Our Ref: ABI/CMO: 190205(3B)

4th September 2023

RE: SECTION 4.55(1A) MODIFICATION APPLICATION TO DA/2016/2890 651 RAYMOND TERRACE ROAD CHISHOLM (LOT 1 DP 1288624) TORRENS TITLE SUBDIVISION - 40 RESIDENTIAL LOTS, 2 RESIDUE LOTS AND ASSOCIATED **INFRASTRUCTURE**

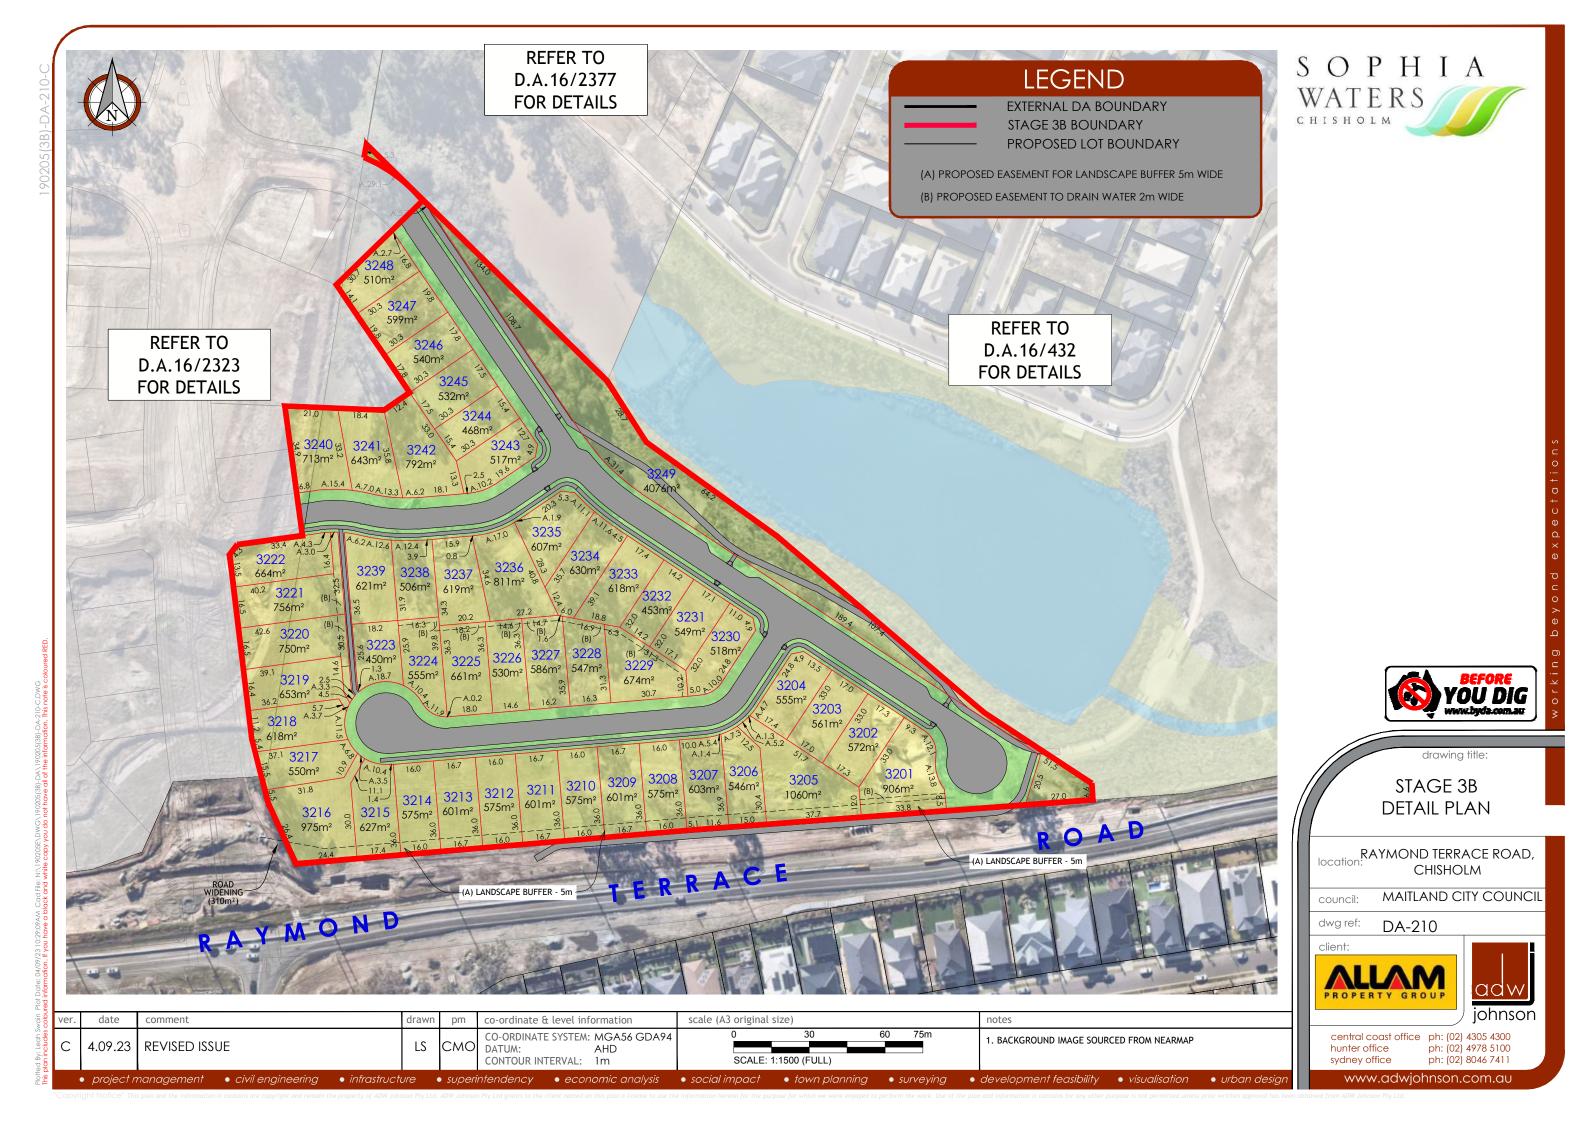
The proposed modification will result in the deletion of the two residue lots, Lot 3242 and Lot 3243 to be replaced by an additional 8 residential lots, resulting in 48 residential lots in total. In addition, residential Lots 3234 – 3241 have slightly been reconfigured. – refer **Figure** 2 below and **Attachment B**.

Revised retaining is required to deliver the abovementioned changes to the layout. Please Refer **Attachment D** for these changes.
